# Access Compliance Report

## Public Rights-of-Way (Curb Ramps)

Intersection ID: 47664	Main Street: ELM_BEND_DR	Cross Street: WRIGLEY_DR	Location: SW
ADA ID: C9E3693BEF0A	Ramp Type: PerpDiag	Initial Pass/Fail: Fail	Overall Compliance: No
		Severity Score: 8.75

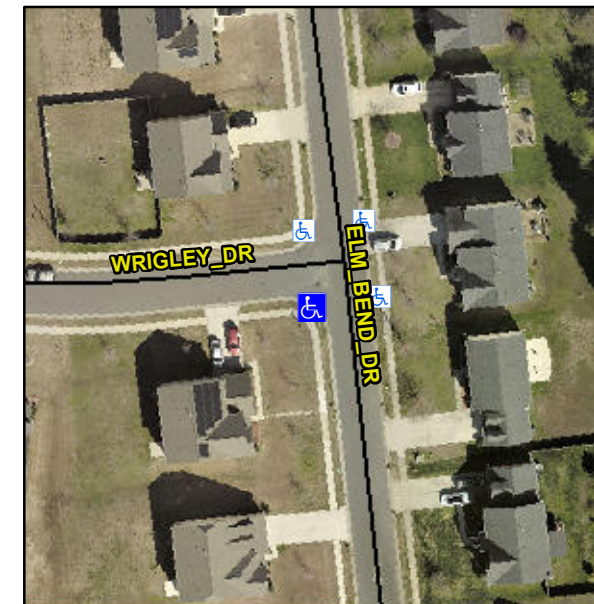
**R304.5.1**

Compliance	Description	Data	Compliance	Description	Data
N/A	Ramp Length (in)	47.0	Yes	Ramp Slope (%)	5.2
No	Ramp Width (in)	46.5	Yes	Ramp XSlope (%)	1.8
N/A	Flare Type LT	N/A	N/A	Flare Type RT	N/A
N/A	Flare Slope LT (%)	N/A	N/A	Flare Slope RT (%)	N/A
N/A	Flare Traversable LT?	N/A	N/A	Flare Traversable RT?	N/A
N/A	Landing Length (in)	N/A	N/A	DWS Provided?	N/A
N/A	Landing Width (in)	N/A	N/A	DWS Contrast?	N/A
N/A	Landing Slope (%)	N/A	N/A	DWS Length (in)	N/A
N/A	Landing X Slope (%)	N/A	N/A	DWS Full Width?	N/A
N/A	Landing Curb? (Y/N)	N/A	N/A	DWS Offset (in)	N/A
N/A	Shared Landing?	N/A			
N/A	Gutter Ponding?	N/A	N/A	Gutter Slope (%)	N/A
N/A	Gutter Lip Ht (in)	N/A	N/A	Gutter X Slope (%)	N/A
N/A	Painted X Walk1?	No	N/A	Painted X Walk2?	No
	X Walk 1 Direction	To E		X Walk 2 Direction	To N
N/A	X Walk 1 Width (in)	N/A	N/A	X Walk 2 Width (in)	N/A
	X Walk 1 Slope (%)	3.2		X Walk 2 Slope (%)	2.6
	X Walk 1 X Slope (%)	2.3		X Walk 2 X Slope (%)	1.6

**Remove & Replace Curb Ramp With Two New Directional Ramps or Equivalent.**
